Docket Number:	18-BSTD-02
Project Title:	2019 ENERGY CODE COMPLIANCE MANUALS
TN #:	224414
Document Title:	SEIA CALSSA Comments on Title 24 Energy Code Compliance Manual Comments - revised letter
Description:	N/A
Filer:	System
Organization:	Evelyn Butler
Submitter Role:	Public
Submission Date:	8/6/2018 11:09:25 AM
Docketed Date:	8/6/2018

**SEIA CALSSA Title 24 Energy Code Compliance Manual Comments -
revised letter**

Re: Dockets 18-BSTD-02: 2019 Energy Code Compliance Manuals and Documents

2) Section 7.8 on page 7-13 for California Fire Code Solar Access Requirements

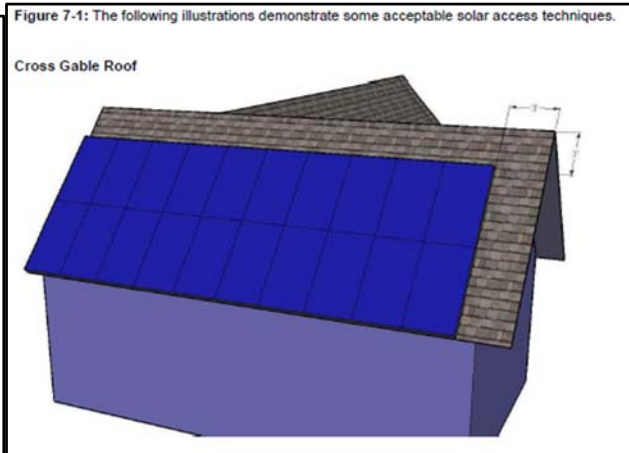
The wording in this section has been deleted in this draft version of the chapter; however, the diagrams for rooftop access pathways and fire setbacks remain and should be updated as a result of the 2016 Intervening Code Cycle Supplement adoption into the 2016 California Codes. The requirements are in the 2016 California Residential Code for one- and two-family dwellings (pp. 111-112) and the 2016 California Fire Code (pp. 107-109) for commercial and multi-family buildings. Further, the diagrams should either be moved into Section 7.8 Solar Zone or retained as a new section

7.9 with the original title (thus requiring renumbering of subsequent sections if the current section order is retained).
